Subject ▶ Change on compression spring 46, gear housing cover, etc.

For Models ▶ HM1800

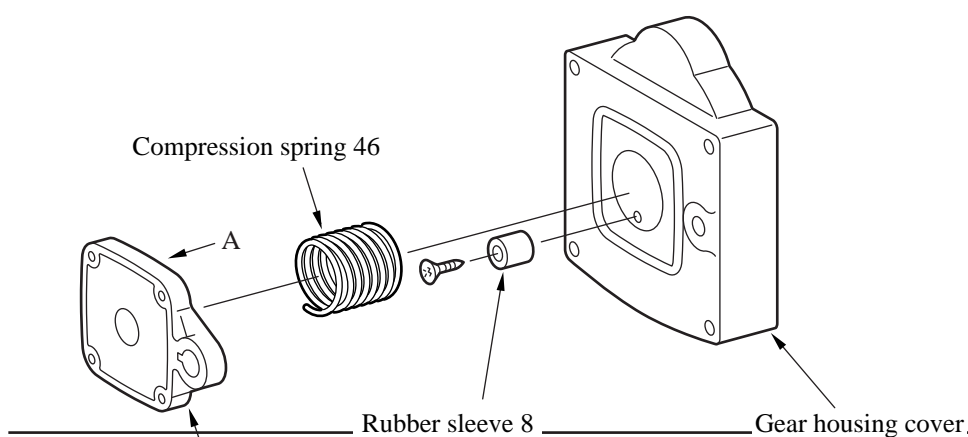
1.Compression spring 46

*The compression spring 46 on the gear housing cover side will be replaced by a compression spring 12. See the figures below.

*The compression spring 46 on the rear case side will be discontinued.

2.Gear housing cover

The portion which accepts the compression spring will be changed in shape as shown in the figures below.

Handle base seen
From side A

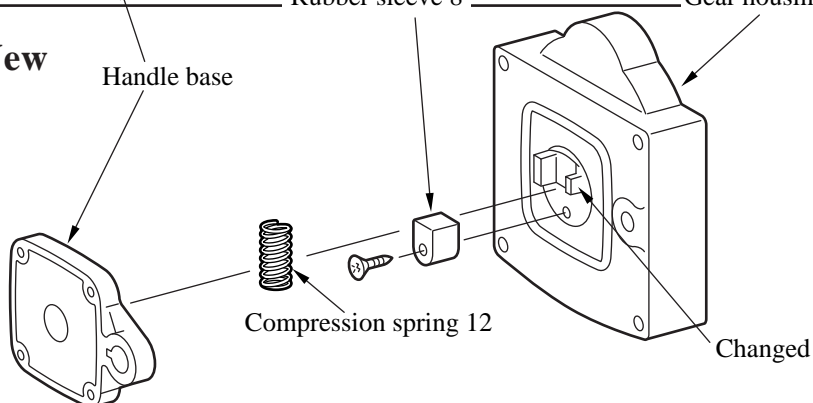
3.Handle base

*The handle bases will be changed in shape as shown in the figures below.

*Note: Not only the handle base on the gear housing cover side but also that on the rear case side will be changed.

4.The rubber sleeve 8 will be changed in shape as shown in the figures below.
